CASE COVER SHEET

City of Rockwall
Planning and Zoning Department
385 S. Goliad Street
Rockwall, Texas 75087

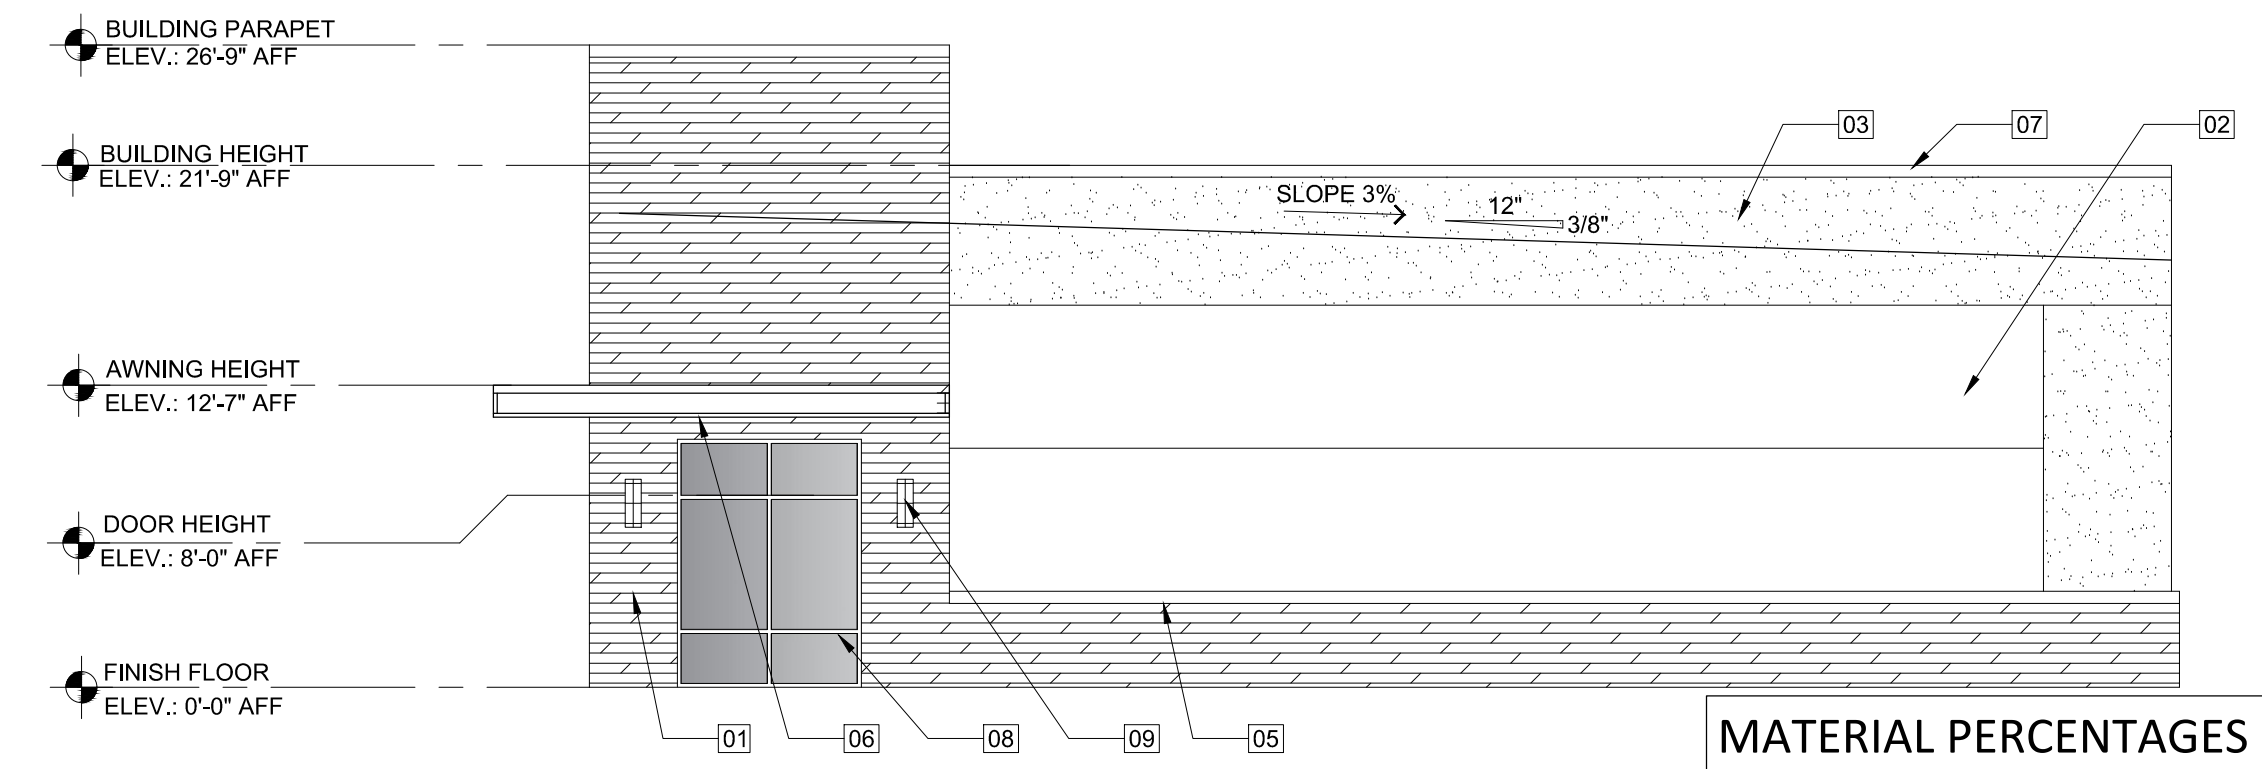
- CONTRACTOR SHALL VERIFY AND COORDINATE ALL NEW AND EXISTING CONDITIONS AND DIMENSIONS AT JOB SITE FOR COMPARISON WITH DRAWINGS AND SPECIFICATIONS PRIOR TO COMMENCING ANY WORK. IF ANY DISCREPANCIES, INCONSISTENCIES OR OMISSIONS ARE FOUND, THE DESIGNER SHALL BE NOTIFIED IN WRITING FOR CLARIFICATION PRIOR TO PROCEEDING WITH WORK.
